Title: DMURS QUALITY AUDIT

**Road Safety Audit Stage 1, Access Audit, Cycle Audit and
Walking Audit.**

**Ratoath Outer Relief Road, Including R155 Signalised
Junction and Internal Development.**

Report reference: 1478R01

LOCATION

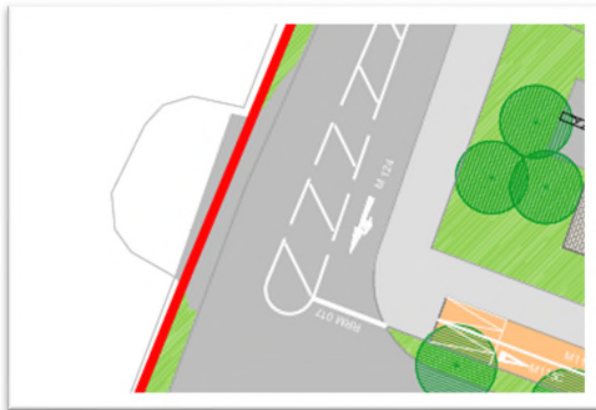
PROBLEM

The proposed right turning lane on the R155 to the relief road appears to be too short to be able to cater for the volume of traffic that would be turning right onto the RORR when it is fully complete and the speed that traffic would be approaching the junction. This could lead to excessive queuing on the R155 which would result in rear-end shunts.

RECOMMENDATION

It is recommended that the right turning lane be extended to cater for the future traffic demand.

planned for in the Part 8 planning scheme.	
3.4	N	N	<p>A traffic analysis has been performed and the queue length calculated.</p> <p>Peak max queue length has been calculated for in 2039 and 15m has been allowed for. Storage capacity is sufficient.</p>	Yes

R155 Pedestrian /cyclist link.

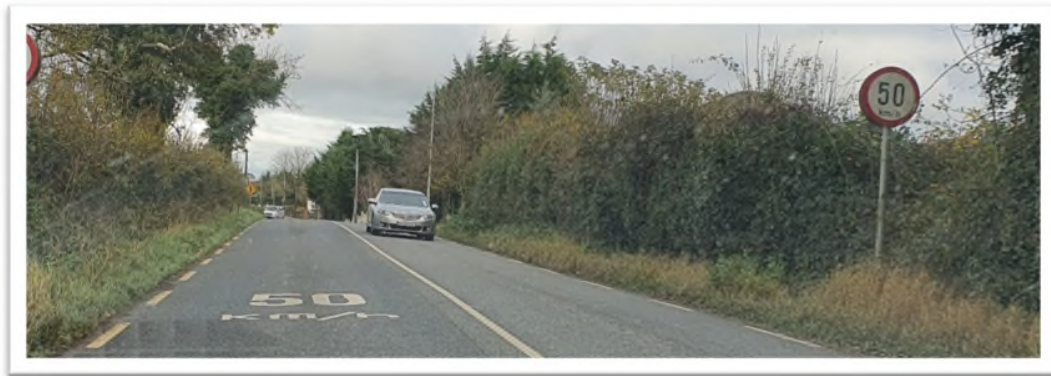
PROBLEM

There is a proposed greenway joining the R155 South of the Carraig Na Gabhna residential development. There is no footpath or cycle track along the R155 for this greenway to connect to. This may lead pedestrians and cyclists entering the carriageway where they would be at greater risk of being struck by passing vehicles.

RECOMMENDATION

It is recommended that a footpath be provided along the R155 from the signalised junction to the existing footpath North of Carraig na Gabhna. A crossing facility of the R155 should be provided at the greenway tie-in to allow cyclists get to the opposite side of the R155 and continue towards the town centre.
